Transport
for NSW

Sydney Harbour Bridge Cycleway - Northern Access Project Design Competition Jury Report

February 2022

Figure 03 Design entry images from Civile team

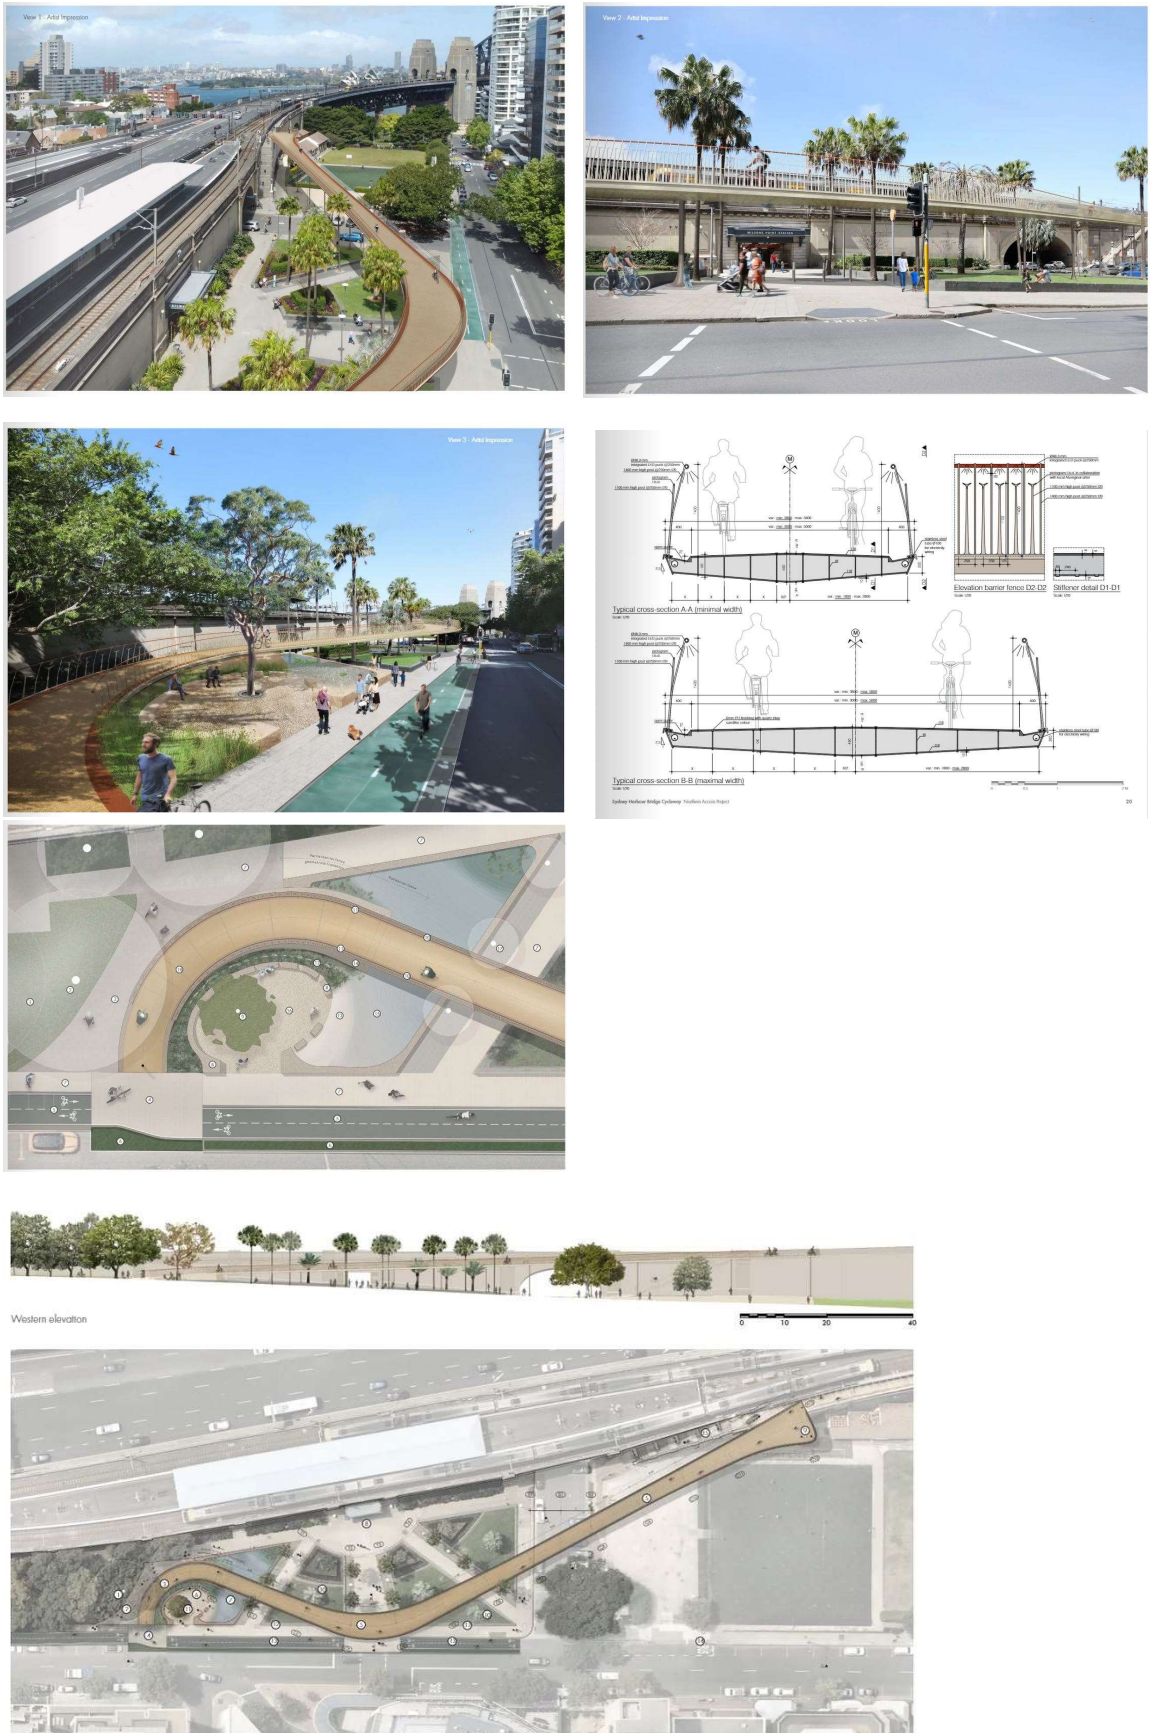
- A well resolved and confident design with a dynamic form that sweeps away from the Bridge viaduct and into Bradfield Park Plaza.
- Having a thorough appreciation of the cycling and pedestrian movements in the precinct, which informed the alignment of the ramp, junction with the existing Sydney Harbour Bridge cycle path and the landing arrangement at the Alfred Street footpath.

- Offering a new meeting place through the provision of seating at the ramp landing in Bradfield Park plaza with minimal impact to existing trees, with the exception of an historic Jelly Palm, which could likely be transplanted. Note: this Jelly palm is separate to the Jelly Palm in the plaza lawn terrace that has recently died.

- Further extending the Reference Scheme heritage strategy of staying clear of the Bridge viaduct wall structure and Railway Station entry, developing a sweeping curve with an alignment that echoes the radial plaza layout whilst ensuring that the ramp is read as an element separate from the Bridge.

- Providing a refined structure and balustrade detailing
- Minimising the visual impact of the ramp structure on the viaduct wall and station entry once inside the 'sweep' of the ramp's curve

- Minimising the impact on Bradfield Park North whilst maintaining the pleasant and well-used pedestrian pathway and view along the curved northern viaduct approach wall, through the ramp's alignment in the plaza and the position of the landing.

- Including several designing with Country themes that would add to the user experience and understanding of place. In particular, the proposals at the ramp landing that integrate water, sandstone and landscape. Integration of water also provides a visible expression of water sensitive urban design.

- One interpretation of this ramp alignment approach (of minimising visual impact of the viaduct wall and station entry from 'inside' the ramp) is that the ramp frames the public open space, enabling the plaza to 'belong' to the Station entry and protecting it from the street. Another interpretation of this outcome is the ramp interrupts State-listed significant views to the curved northern approach of the Bridge (SHR00781) and diminishes the spatial integrity and open sky experience of the plaza, visually cutting it off from the street. It is noted that the Bradfield Park setting has "Exceptional" heritage grading (per the SHB Conservation Management Plan) and includes Milsons Point Station, entrance, canopies and plaza area and Bradfield Park North.

- Encroaching over the Alfred Street footpath, affecting State-listed significant view to the Harbour Bridge particularly from a southern approach on Alfred Street. A narrowing of the wide ramp deck could reduce this impact.

- Affecting heritage significant views of the plaza, Bridge wall, the date and cartouche above the Station canopy and Station from Alfred Street, when outside the 'sweep' of the ramp's curve.

- Requiring further design development to ensure that the slender ramp structure, slender columns and crafted balustrade are achievable. Despite assurances of previous European precedents, the Jury considered the design would need to address structural and vibration requirements to develop column sizing and connection details, consider footing constraints that may affect column spacing and further develop soffit details/materials/finishes.

- Requiring further review of the generous ramp width. Whilst acknowledging the benefit of having extra cycling space on curves and on steeper gradients, the ramp widening up to approximately 5.8m at Alfred Street at a relatively low height could be overbearing for pedestrians and impact views down Alfred Street toward the Bridge pylons and arch.

- Requiring further review of the ramp height over the northern diagonal pedestrian path, which at approximately 2.4m to the underside of the ramp is not a height suitable in a public space and could feel overbearing. The ramp could be increased in height at this location through steepening the ramp gradient. It is acknowledged that a steeper gradient could have implications on reducing the ramp width as suggested in the preceding point.

- Investigate the ramp alignment both in the plaza and at the ramp landing to minimise impacts to existing trees including the historic Jelly Palm and the mature Chinese Elm which has a raised rootzone in the landing area.

Figure 04 Design entry images from ASPECT Studios

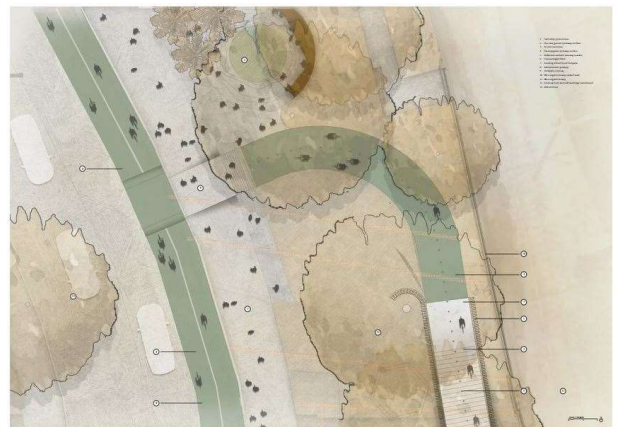
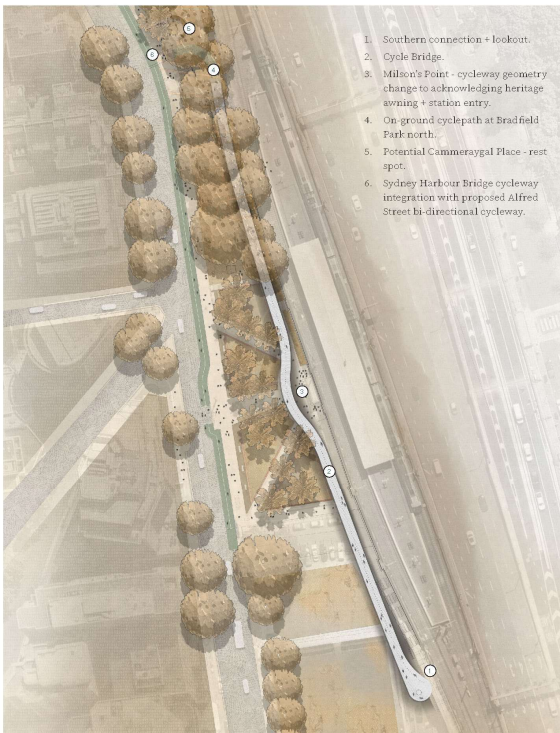
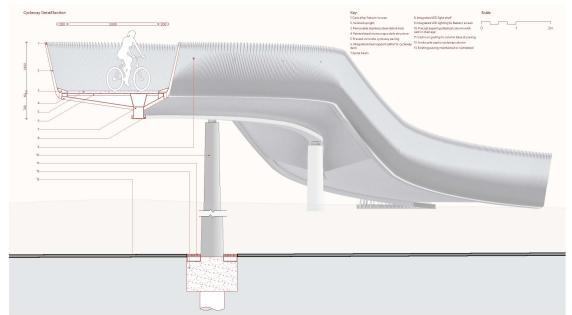
- An elegant and streamlined design that prioritises the open space setting of Bradfield Park plaza, consistent with the Design Principles defined in the Services Brief.

- Providing a relationship between the historic Bridge and new transport infrastructure through aligning with the approach curve of the viaduct and offsetting at the Railway station entry portico.

- Retaining legibility and sightlines to the Railway Station entry portico from different viewpoints through the soft curved alignment with the radial plaza layout and height of the ramp. Whilst clearly an intervention, the existing uses of the Bradfield Station plaza mostly remain intact.

- Offering a gentle cycle grade and a clear and direct route for the majority of cyclists moving through the precinct to or from the north.
- Locating the landing point of the ramp further north, where the pedestrian traffic is not as heavy as it is further south around the plaza and pedestrian crossing.

- Minimising impact to existing trees, paths and gardens within Bradfield Park plaza and minimising the visual impact of the ramp structure on views along Alfred Street toward Harbour Bridge through the ramp's alignment with the viaduct

- Creating a sophisticated design response through the thoughtful detailing of the structure and balustrade.
- Providing a not overtly literal response to designing with Country themes, primarily the whale inspiration for the balustrade concept.

- One interpretation of this ramp alignment approach (of minimising impact on Bradfield plaza and the Alfred Street views) is that the plaza, and in particular the landscaped terraces, is able to be a predominantly uninterrupted landscaped space that is open to the sky and a clear part of the public realm of the street, with views retained to the Harbour Bridge arch from Alfred Street footpath. Another interpretation of this outcome is the ramp impacts the reading and full appreciation of the viaduct wall and the station entry and interrupts the significant view along the northern approach as seen in Bradfield Park North. The aesthetic significance of the curved northern approach with continually changing views of the Bridge and harbour is identified in the statement of significance as part of the State heritage listing of the Sydney Harbour Bridge, approaches and viaducts (road and rail) SHR00781. It is noted that the Bradfield Park setting has "Exceptional" heritage grading (per the SHB Conservation Management Plan) and includes Milsons Point Station, entrance, canopies and plaza area and Bradfield Park North.

- Having a long extension and therefore encroachment into Bradfield Park north due to the gentle ramp gradient. Further review is required which could consider steepening the ramp once beyond the plaza to minimize this encroachment.

- Impacting the continuity of the State-listed heritage significant view along the viaduct approach wall, when approaching through Bradfield Park North, and obscuring part of the design detailing at the top of the approach wall and the date and cartouche above the station canopy.

- Creating two potential points of pedestrian/cyclist conflict – one in Bradfield Park North and one at the footpath on Alfred Street (as opposed to just Alfred Street). Further review is required to resolve the interface with the pedestrian park within the path, and enable its continuity.

- Removing a significant portion of the well-used pedestrian pathway that runs along the viaduct wall in Bradfield Park north, requiring pedestrians to divert and join the footpath on Alfred Street. A closer or further offset alignment to the viaduct wall could enable this path to be reshaped or maintained. It is acknowledged that a closer alignment may create a requirement for review of throw screens on the ramp or potentially atop of the wall, in addition to removal of a number of Poplar trees. (It is noted that these trees are not significant and provide current technical challenges due to their proximity to the rail corridor.)

- Requiring refinements to the balustrade such as the cycling bump rail, or consideration of a vertical rather than angled alignment. Future design development could also consider a recessed structural beam.

- Requiring more meaningful Designing with Country expression to ground the design in 'belonging' to the park and the Bridge.
